Access Compliance Report

Public Rights-of-Way

(Curb Ramps)

Intersection ID: 2733	Main Street: CARDINAL_POINT_RD	Cross Street: SWEETFIELD_DR	Location: W
ADA ID: F13069E0BE1A	Ramp Type: Perp	Initial Pass/Fail: Fail	Overall Compliance: No
Severity Score: 13.75			
Codes/Mitigation Info/Possible Solution		Field Measurements/Component Compliance

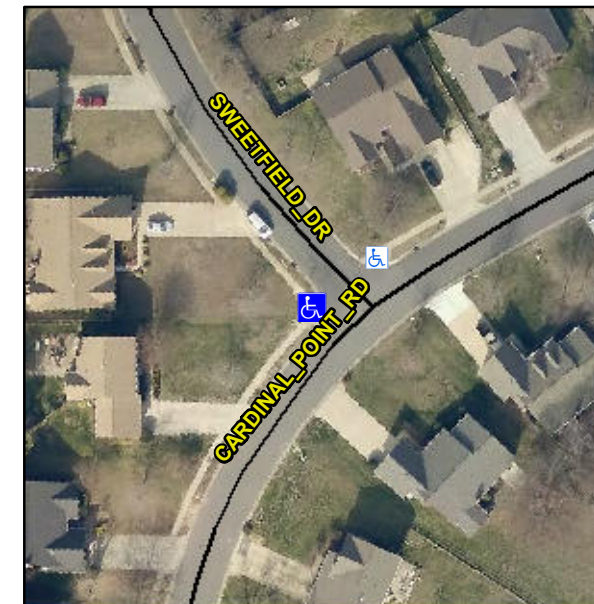
R304.2.2, R304.5.3

Compliance	Description	Data	Compliance	Description	Data
N/A	Ramp Length (in)	54.5	No	Ramp Slope (%)	10.3
Yes	Ramp Width (in)	53.0	No	Ramp XSlope (%)	4.5
N/A	Flare Type LT	N/A	N/A	Flare Type RT	N/A
N/A	Flare Slope LT (%)	N/A	N/A	Flare Slope RT (%)	N/A
N/A	Flare Traversable LT?	N/A	N/A	Flare Traversable RT?	N/A
N/A	Landing Length (in)	N/A	N/A	DWS Provided?	N/A
N/A	Landing Width (in)	N/A	N/A	DWS Contrast?	N/A
N/A	Landing Slope (%)	N/A	N/A	DWS Length (in)	N/A
N/A	Landing X Slope (%)	N/A	N/A	DWS Full Width?	N/A
N/A	Landing Curb? (Y/N)	N/A	N/A	DWS Offset (in)	N/A
N/A	Shared Landing?	N/A			
N/A	Gutter Ponding?	N/A	N/A	Gutter Slope (%)	N/A
N/A	Gutter Lip Ht (in)	N/A	N/A	Gutter X Slope (%)	N/A
N/A	Painted X Walk1?	No	N/A	Painted X Walk2?	N/A
	X Walk 1 Direction	To NE		X Walk 2 Direction	N/A
N/A	X Walk 1 Width (in)	N/A	N/A	X Walk 2 Width (in)	N/A
	X Walk 1 Slope (%)	0.1		X Walk 2 Slope (%)	N/A
	X Walk 1 X Slope (%)	4.4		X Walk 2 X Slope (%)	N/A

Remove & Replace Entire Ramp.
